WATERBURY FILING NO. 1 EL PASO COUNTY, CO CONSTRUCTION SET FEBRUARY 2023

EPC STORMWATER REVIEW COMMENTS IN ORANGE BOXES WITH BLACK TEXT

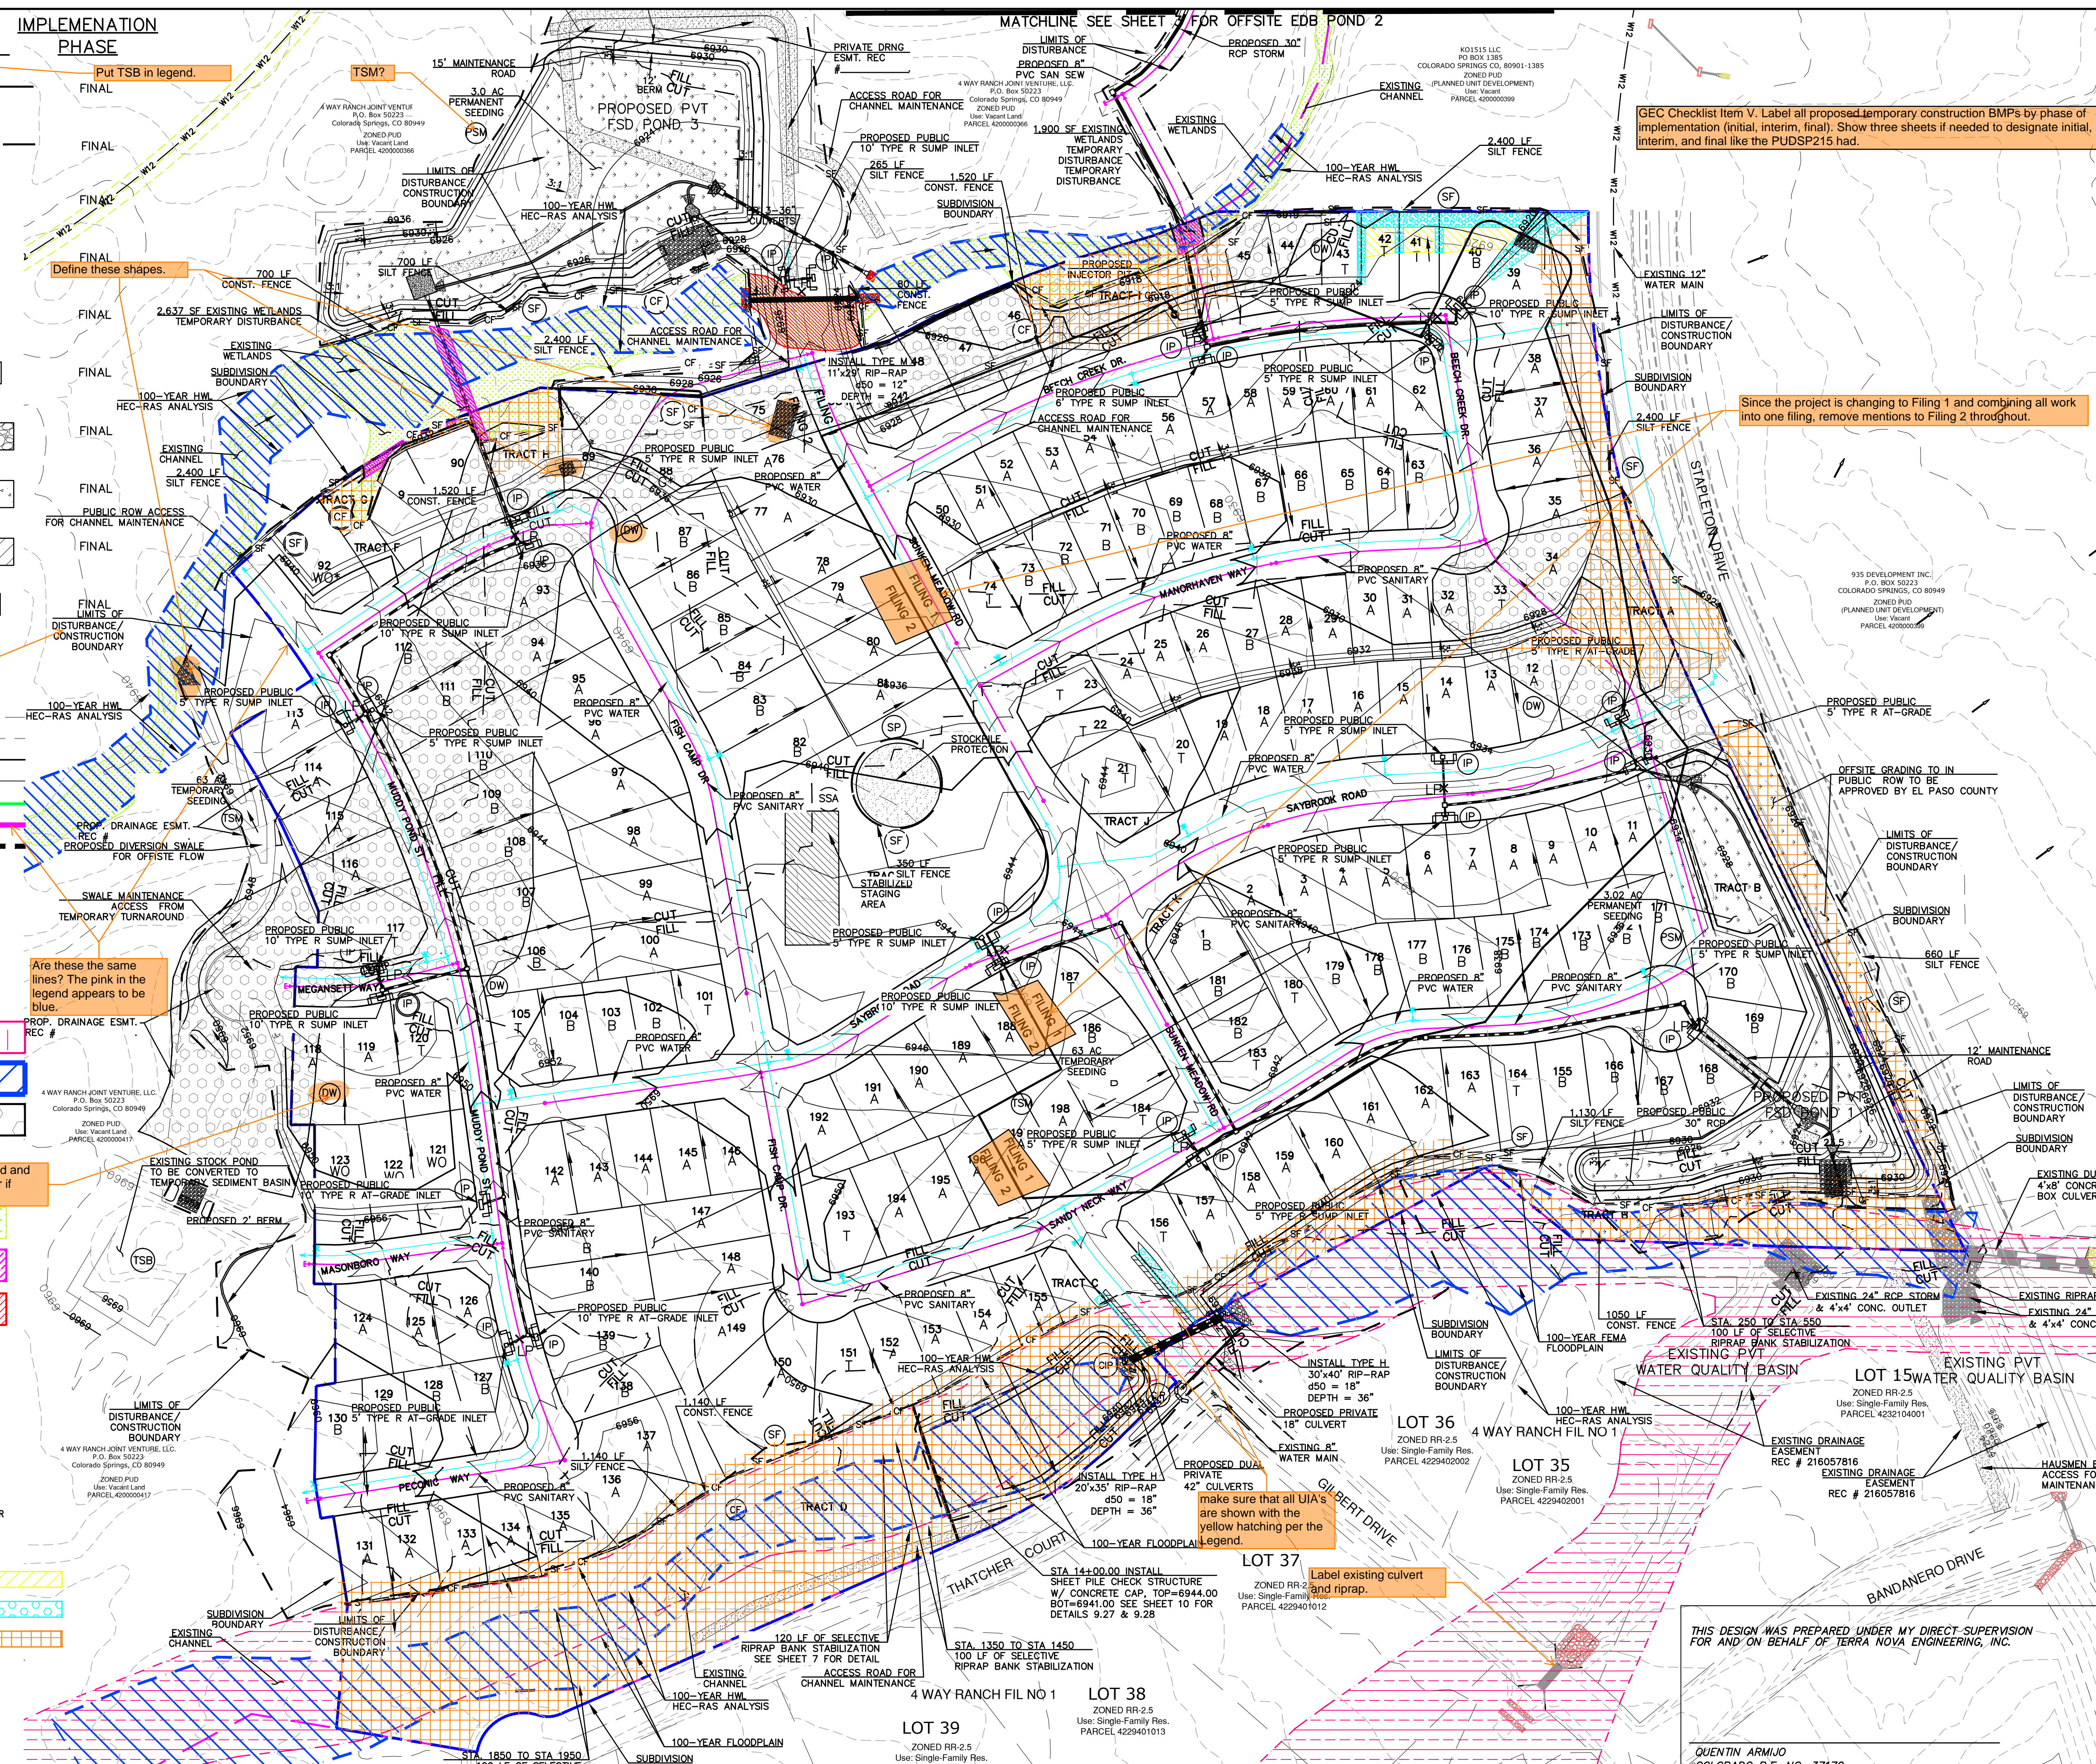
Add a general note: all areas to be vegetated with permanent seeding should also be temporary stabilized via track rolling or some other means.

GEC Checklist Item V. Label all proposed temporary construction BMPs by phase of implementation (initial, interim, final). Show three sheets if needed to designate initial, interim, and final like the PUDSP215 had.

Since the project is changing to Filing 1 and combining all work into one filing, remove mentions to Filing 2 throughout.

Are these the same lines? The pink in the legend appears to be blue.

Put DW in legend and provide detail for if needed.

make sure that all UJA's are shown with the yellow hatching per the legend.

Label existing culvert and riprap.

DESIGNED BY DLF	DRAWN BY QNA
CHECKED BY QNA	H-SCALE NA
V-SCALE N/A	JOB NO. 1715.00
DATE ISSUED 2/6/23	SHEET NO. 6 OF 39

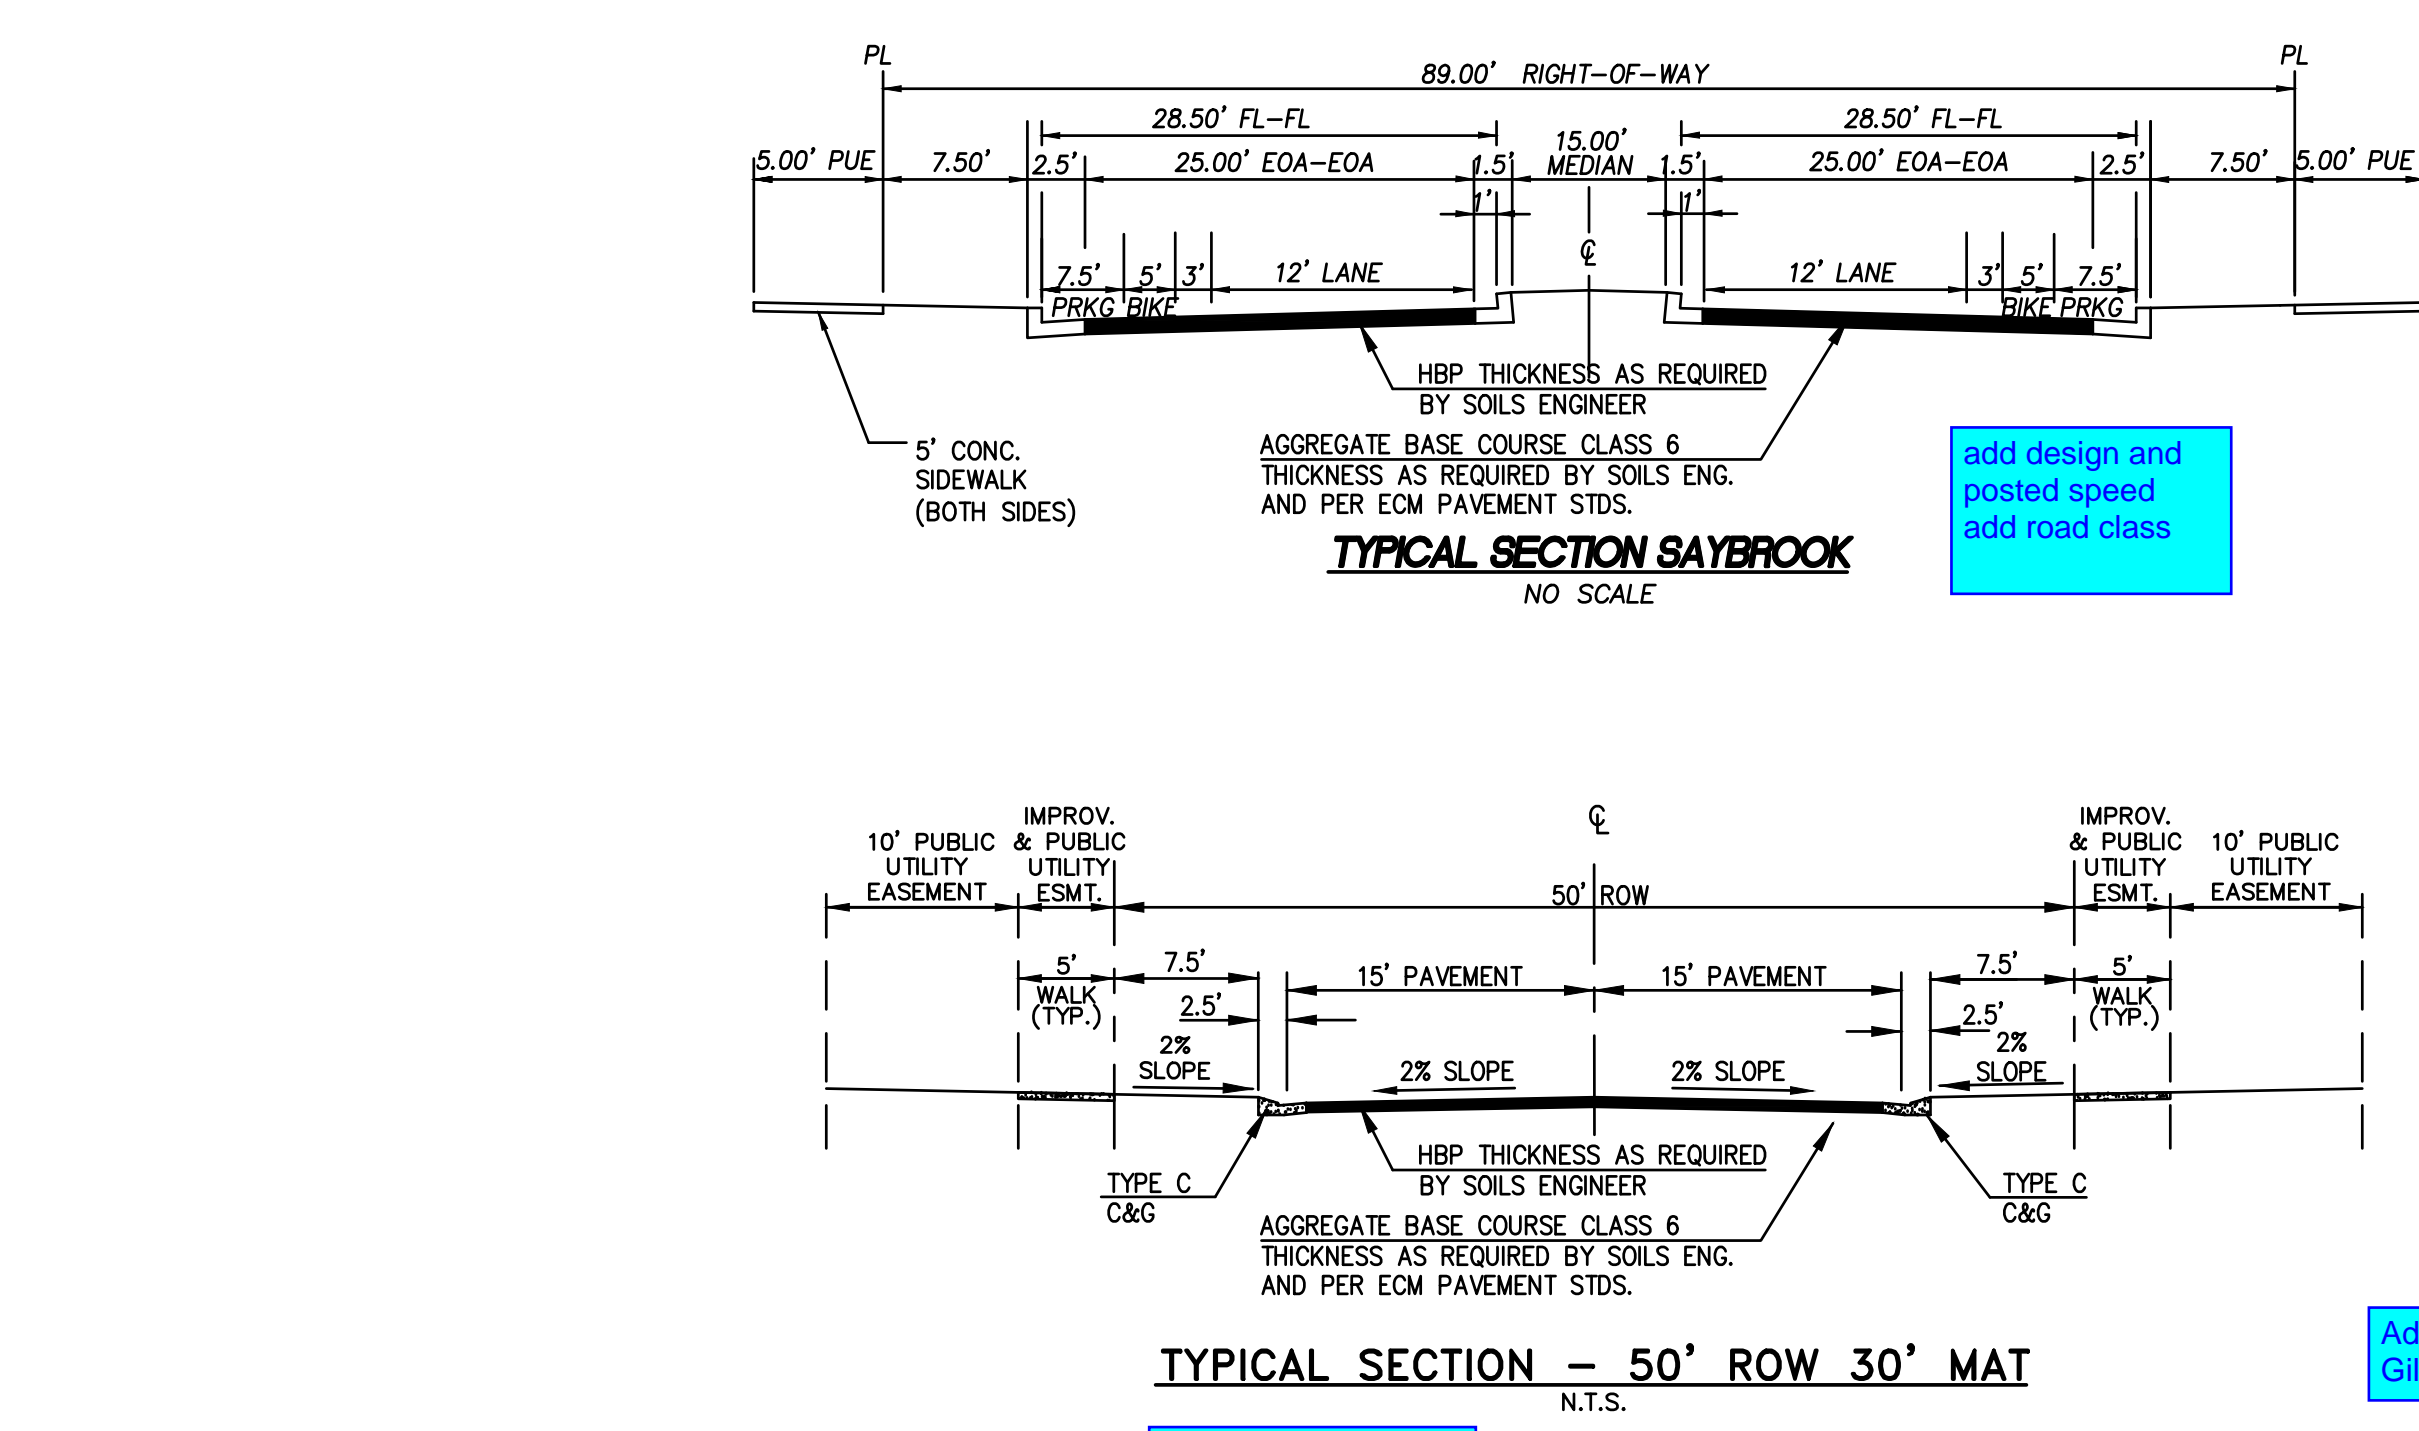
Add details for the construction fence and culvert inlet protection.

JOB NO. 1715.00  
 DATE ISSUED 2/6/23  
 SHEET NO. 7 OF 39

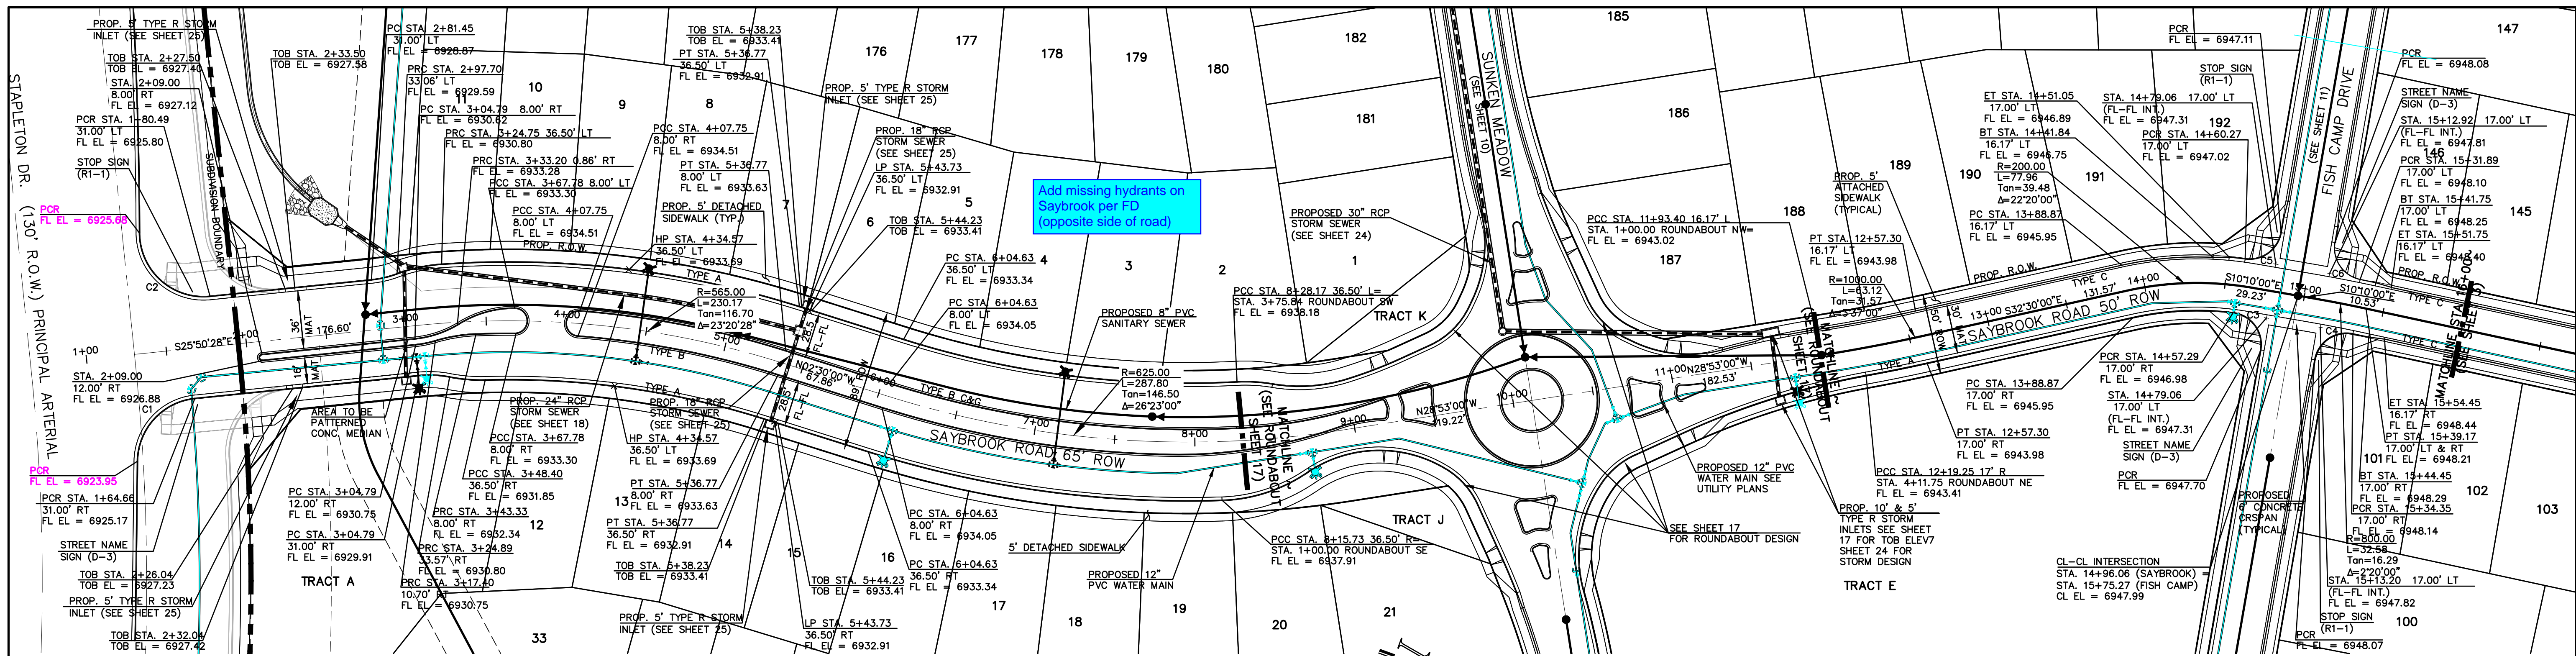
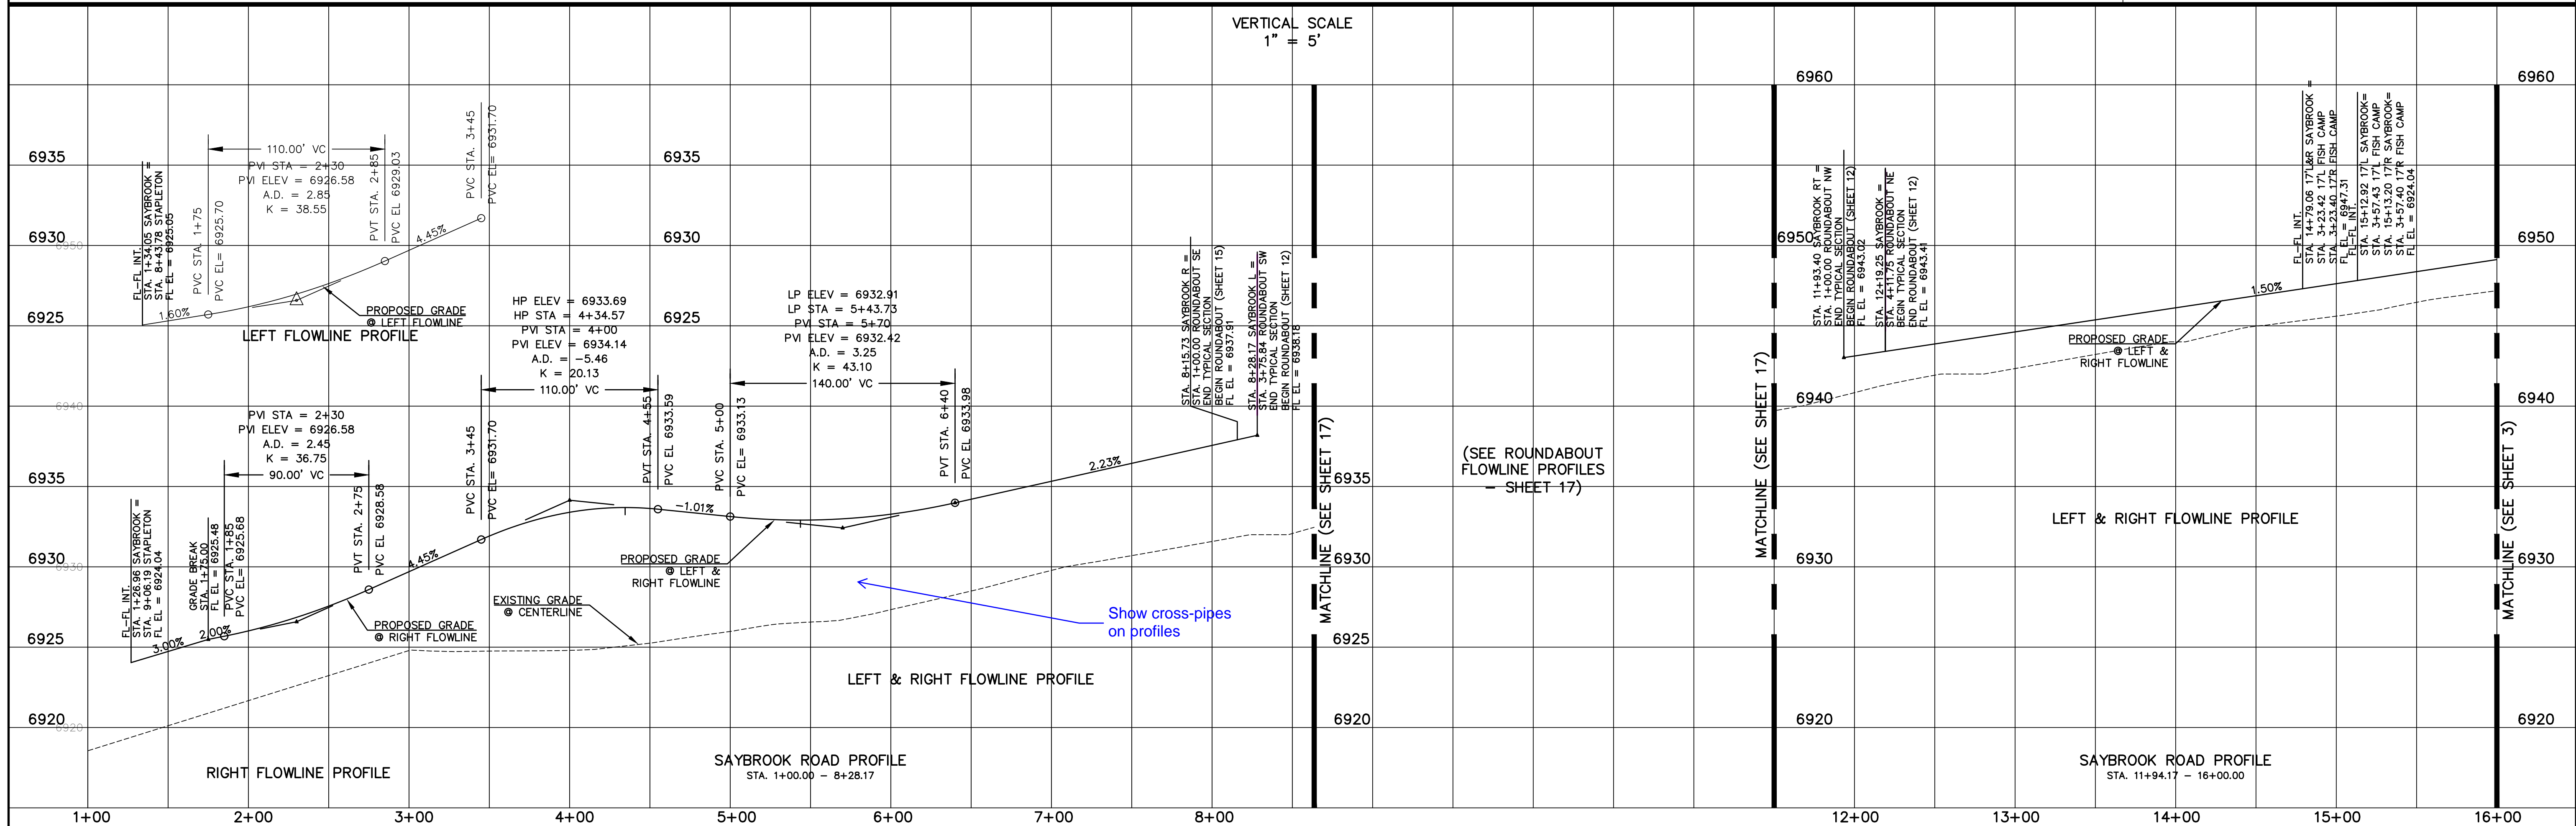
Add speed limit sign on entry to subdivision

Add speed limit sign

Note: street and storm plan and profile review was preliminary on this submittal; more detailed review will be provided with the next submittal.
